Design Standards
and Guidelines
Errata

April 09, 2021

ERRATA

This Errata is an attachment to the [Downtown West Design Standards and Guidelines \(DWDSG\) issued on March 1, 2021](#). Together the Errata and DWDSG comprise a full and complete record of the vision, requirements, and recommendations for new development within the Downtown West Mixed-Use Plan.

FIGURE 1.8: DWDSG framework plan

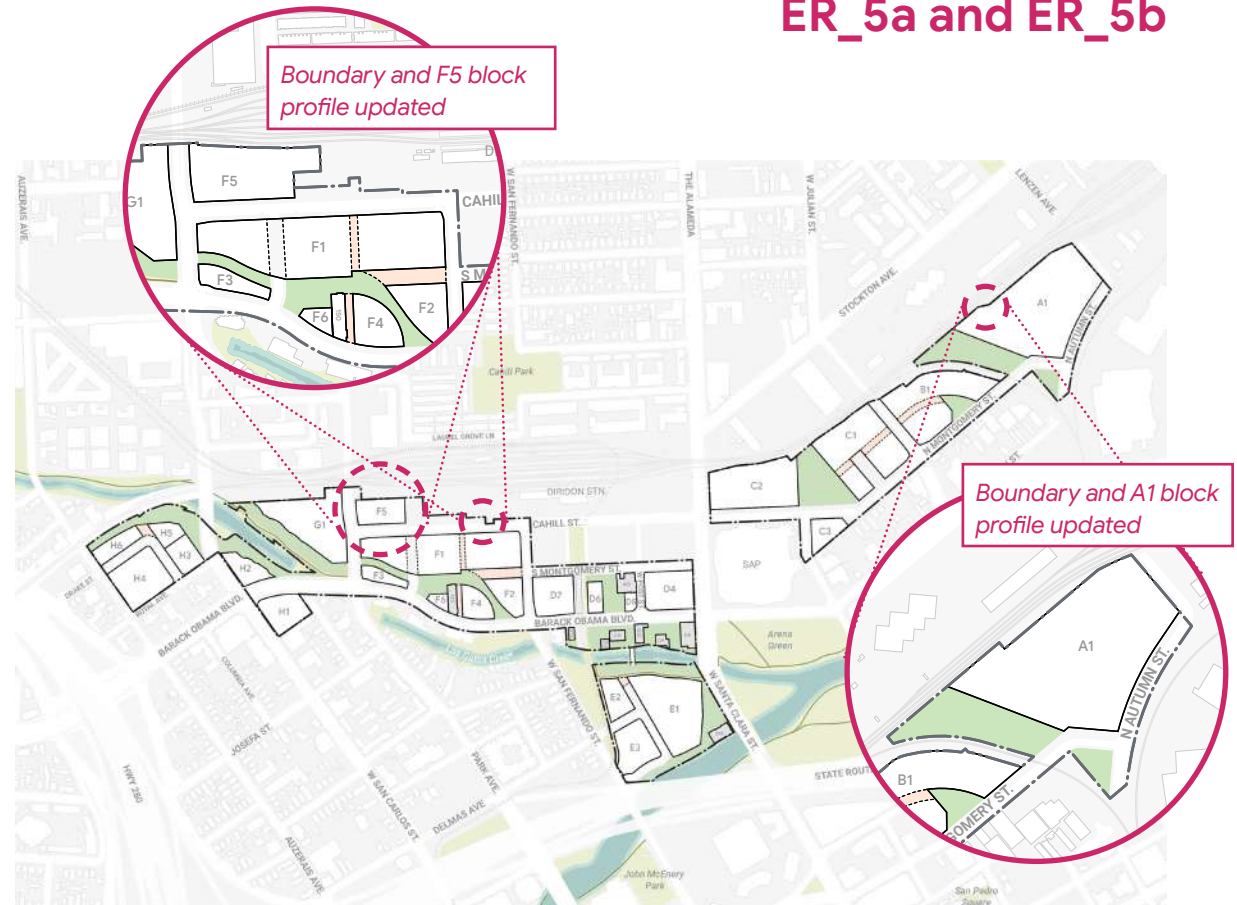
ER_5a	21	Document Overview	Figure 1.8	Site boundary and block profile changes at F5 and A1
ER_5b	21	Document Overview	N/A	The standards and guidelines in the DWDSG permit a limited range of land uses, massing, and circulation options, which may result in a block plan that differs from the DWDSG framework plan. Refer to the Vesting Tentative Map and subsequent Final Maps for dimensioned lot boundaries.
ER_6	30	Project Vision	Figure 2.2	Site boundary and block profile changes at F5 and A1
ER_7	49	Land Use	Figure 3.2	Site boundary and block profile changes at F5 and A1
ER_8	52	Land Use	Figure 3.3	Site boundary and block profile changes at F5 and A1 and southern infrastructure zone boundary extension
ER_9	56	Land Use	Figure 3.6	Site boundary changes and removal of non-building elements identified for demolition
ER_10a	71	Open Space	S4.5.2	“A minimum of 4.80 acres of the approximately 15 total acres of Project open space shall be City-dedicated open space, and shall, at minimum, meet the total acreages shown for Los Gatos Creek Multi-Use Trail and City-dedicated parks identified in Table 4.1: ”

FIGURE 3.6: Demolition and retention plan

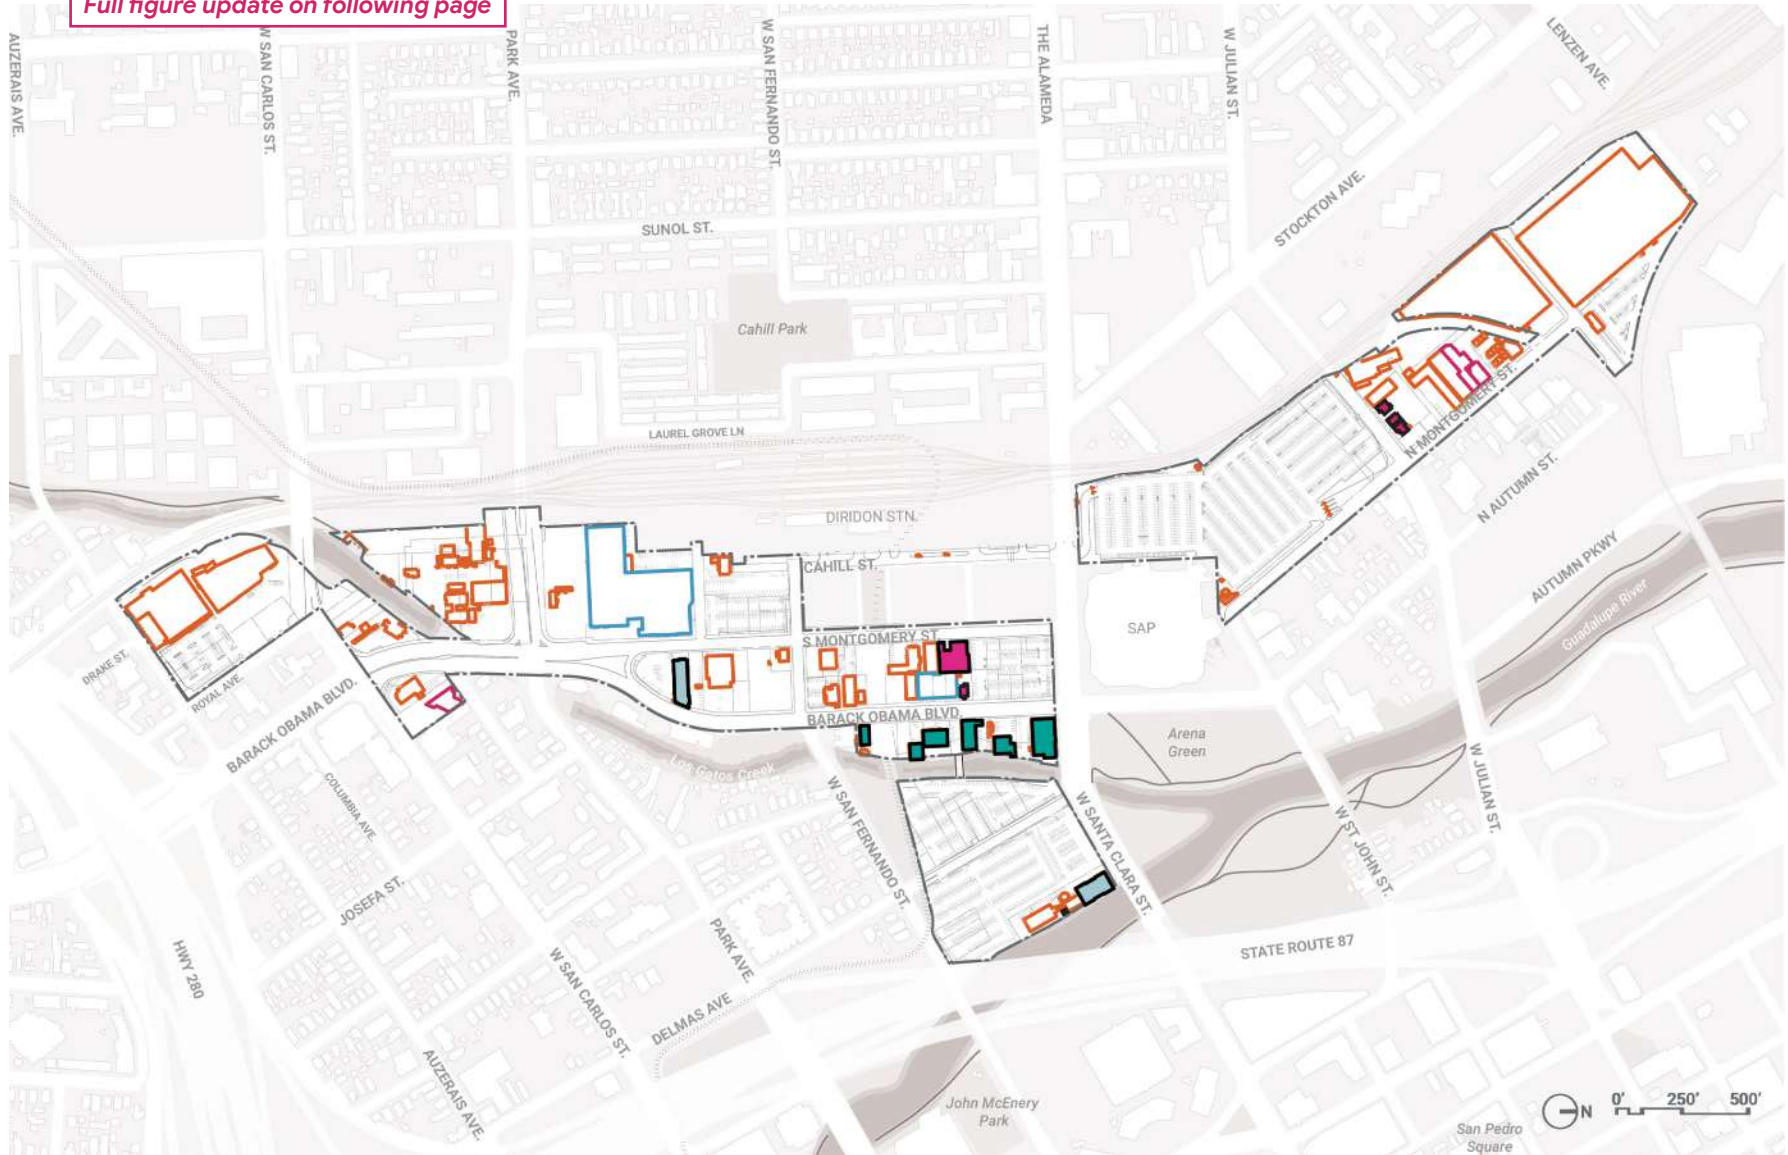
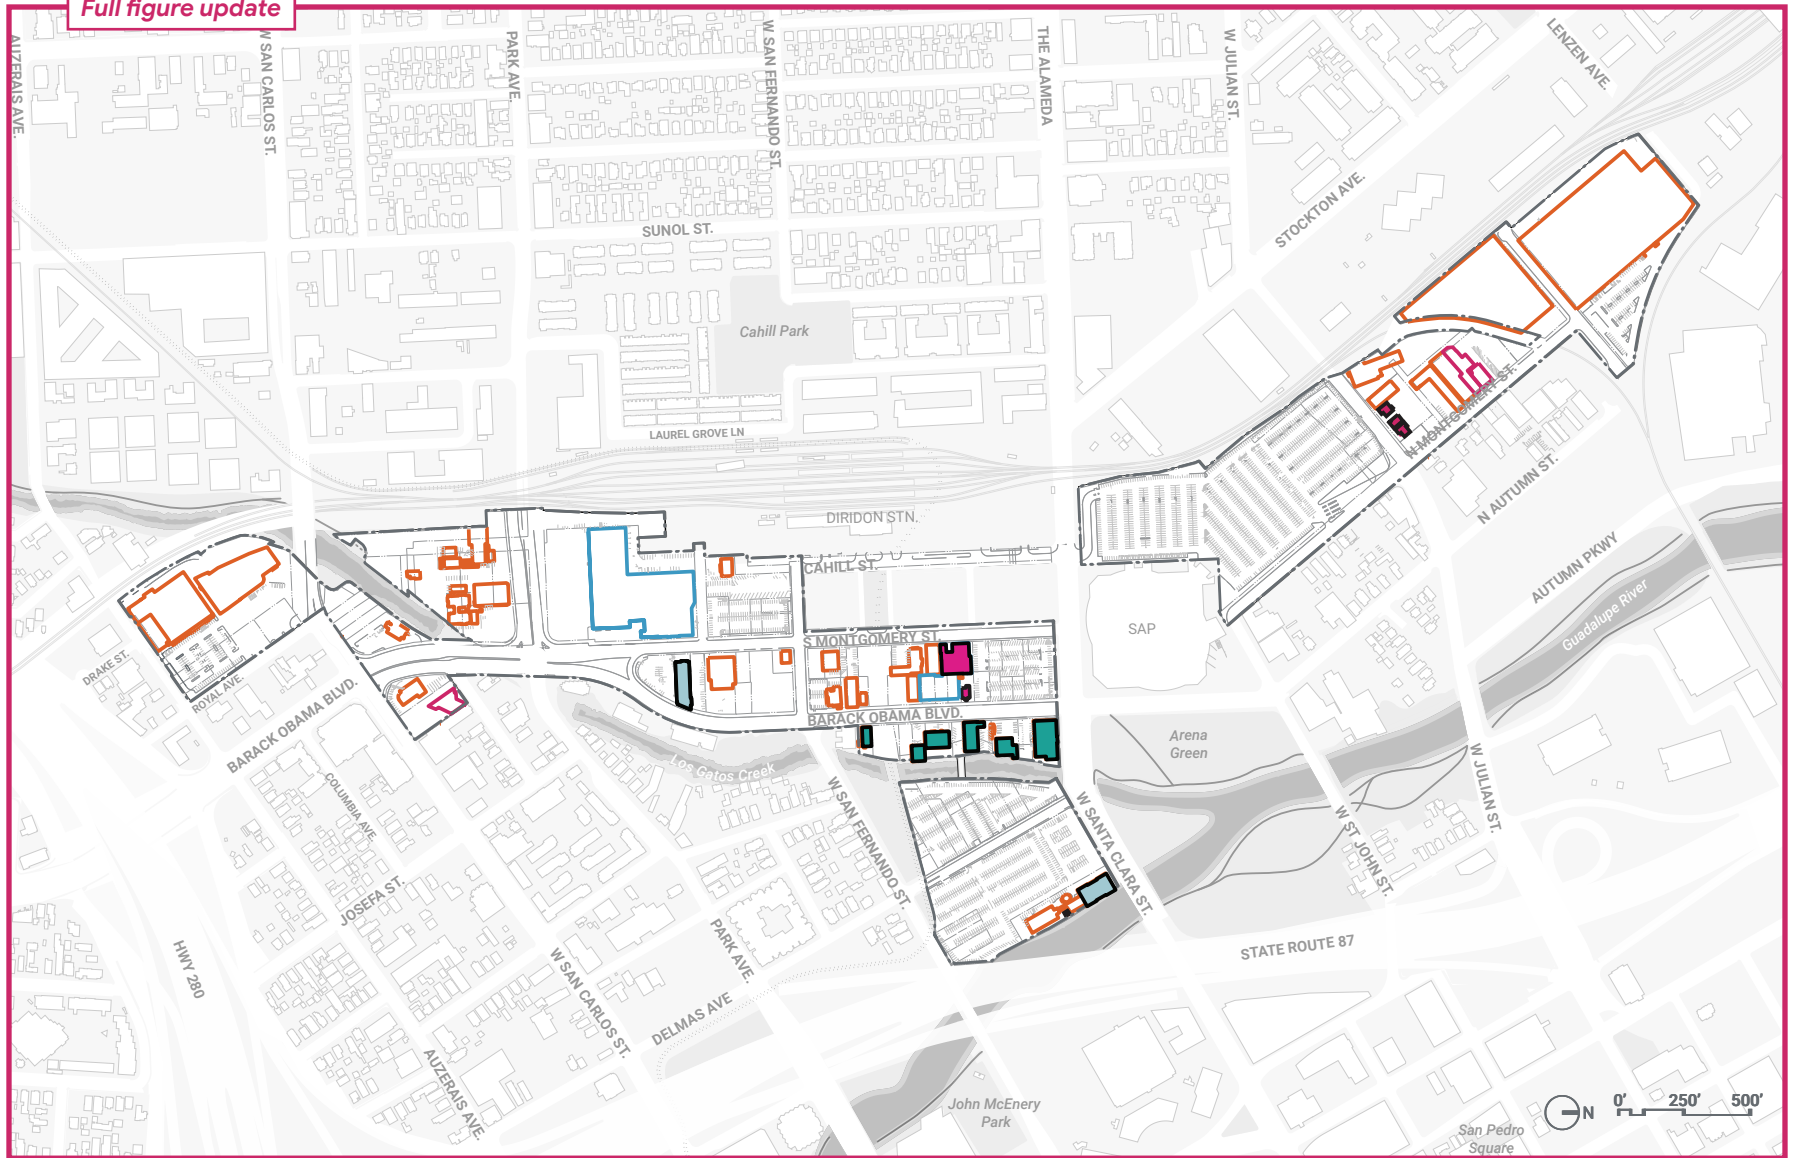
Full figure update on following page

Full figure update

FIGURE 4.49: Illustrative plan of Gateway to San José

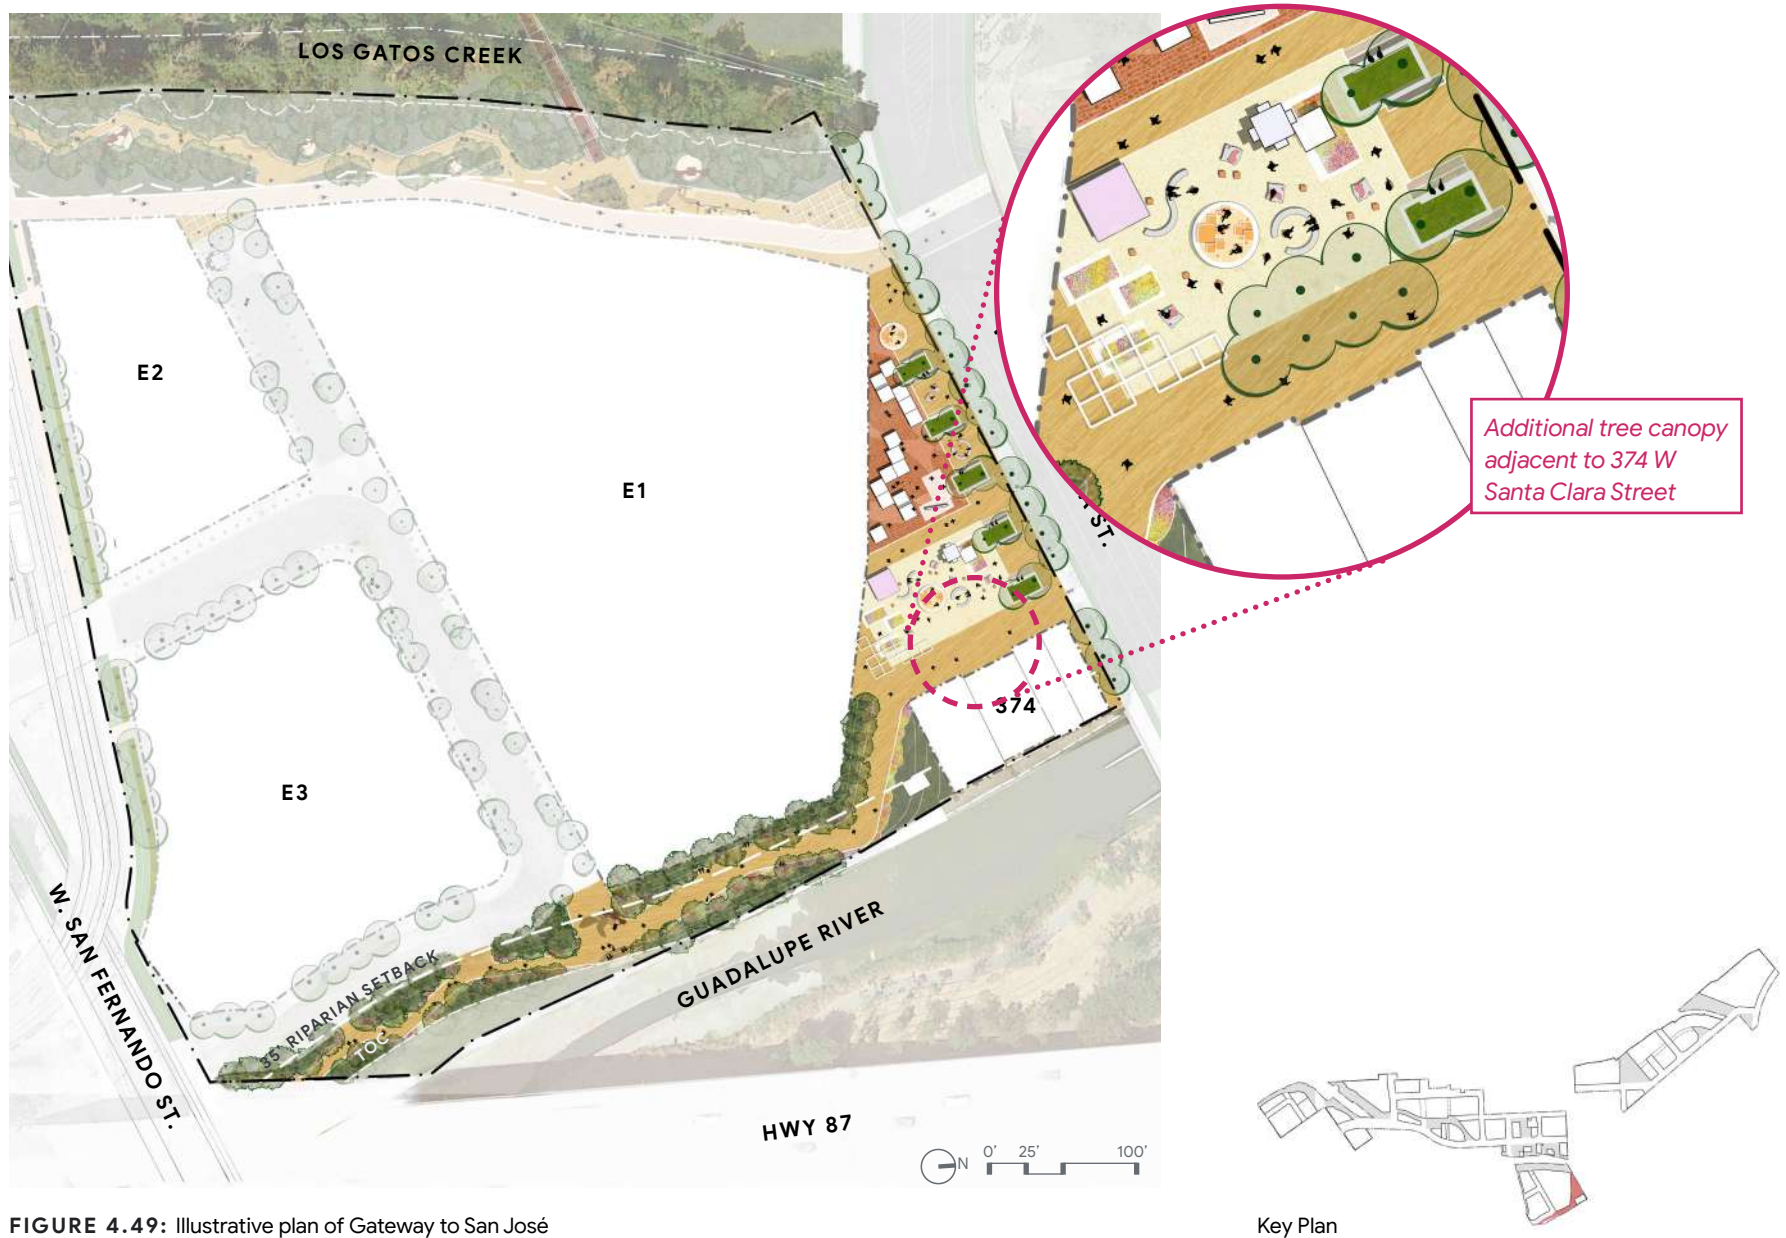
ERRATA ID	DWDSG PAGE NUMBER	DWDSG CHAPTER	DWDSG CONTENT	DESCRIPTION OF UPDATES
ER_10c	134	Open Space	Figure 4.49	Additional tree canopy adjacent to 374 W Santa Clara Street
ER_10d	136	Open Space	Figure 4.50	Additional tree canopy adjacent to 374 W Santa Clara Street
ER_10e	148	Open Space	Figure 4.60	Additional tree canopy adjacent to 374 W Santa Clara Street
ER_11	150	Open Space	Table 4.15	Addition of “California Hazelnut, <i>Corylus cornuta</i> Marsh. var. <i>californica</i> ” to plant species list
ER_12	156	Open Space	S4.25.4	“Serviced and unserviced pavilion structure that use glazing as a material shall provide glazing units with visible light transmittance below 60 percent which shall not count toward the required transparent area. Existing structures that are relocated as pavilions shall be exempt from transparency requirements. ”
ER_13	156	Open Space	S4.25.6	“Public restrooms, park maintenance and storage facilities, and park management offices shall be permitted supportive structures for open spaces active uses; see Section 3.1. No single park maintenance structure shall exceed 1,500 square feet in interior area. Park maintenance structures shall not exceed 20 feet in height above finished grade as measured to top of roof. Park maintenance structures are permitted in either the open space or the interior of an adjacent building, new development blocks, or other space outside of street right-of-way. If provided as a standalone structure in the open space, the structure size cannot exceed the maximum cover limit described in Table 4.16.”

FIGURE 5.7: Architectural requirement summary

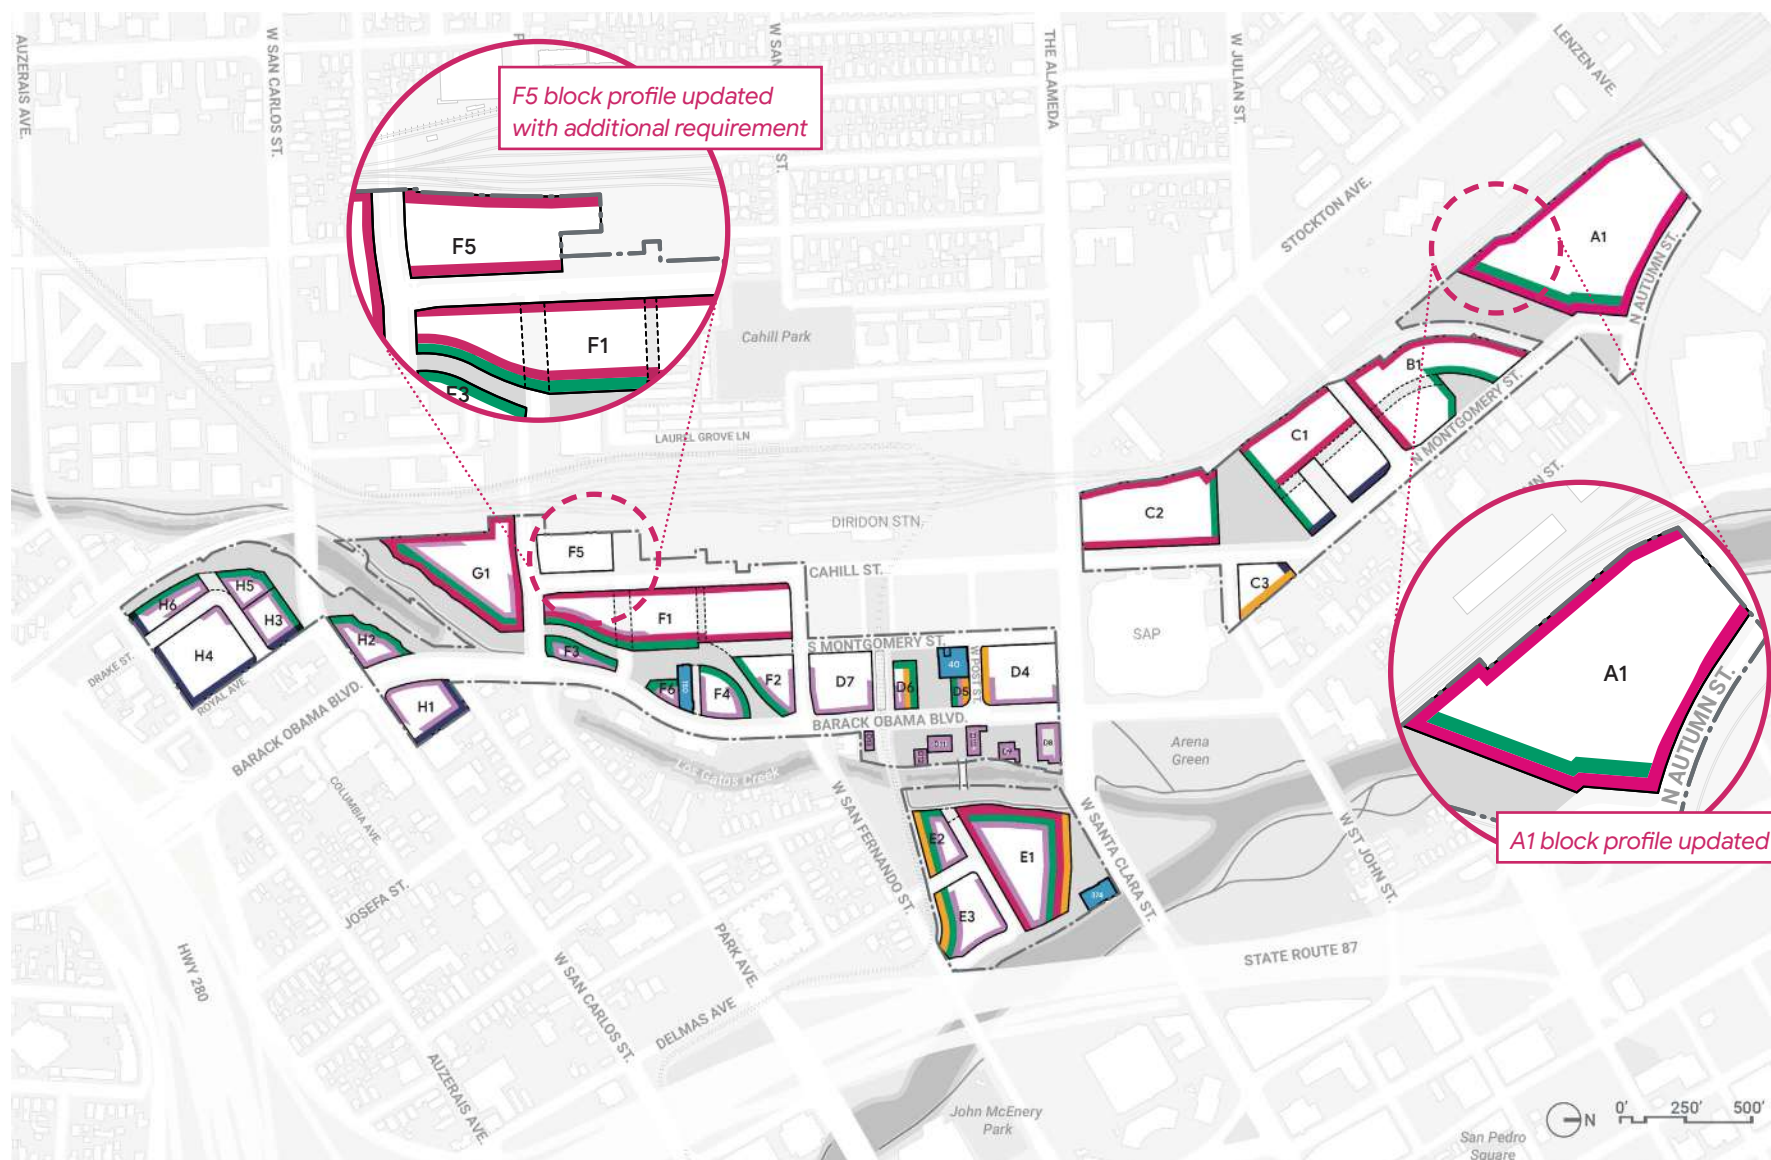
ER_14	170	Buildings	Figure 5.7	Addition of long facade demarcation on F5 east (secondary) and F5 west (primary).
ER_15	171	Buildings	Table 5.1	Addition of long facade demarcation on F5
ER_16	173	Buildings	Figure 5.9	Site boundary changes at F5 and A1
ER_17	176	Buildings	S5.5.7	<p>“ • The existing structure at block D13 shall be replaced by the relocated 35 South Autumn Street (Barack Obama Boulevard) main structure (see S5.15.3). The structure from 35 South Autumn Street shall be relocated within the building footprint of 74 South Autumn (Barack Obama Boulevard) and outside of the 50-foot Los Gatos Creek Riparian Setback.</p> <p>• If the property owner elects to demolish any building on blocks D9 or D12-D12-or-D13, the property owner is permitted to replace the demolished built area in a new building elsewhere in Creekside Walk. Replacement structures for blocks D9 or D12-D12-and-D13 shall not encroach into the 50-foot Los Gatos Creek Riparian Setback. Individual replacement structures shall be permitted to exceed the gross square footage of the existing structure in accordance with the square footage limits of additions described below. Replacement structures are subject to applicable standards in Sections 5.6, 5.7, 5.8, and 5.13.”</p>
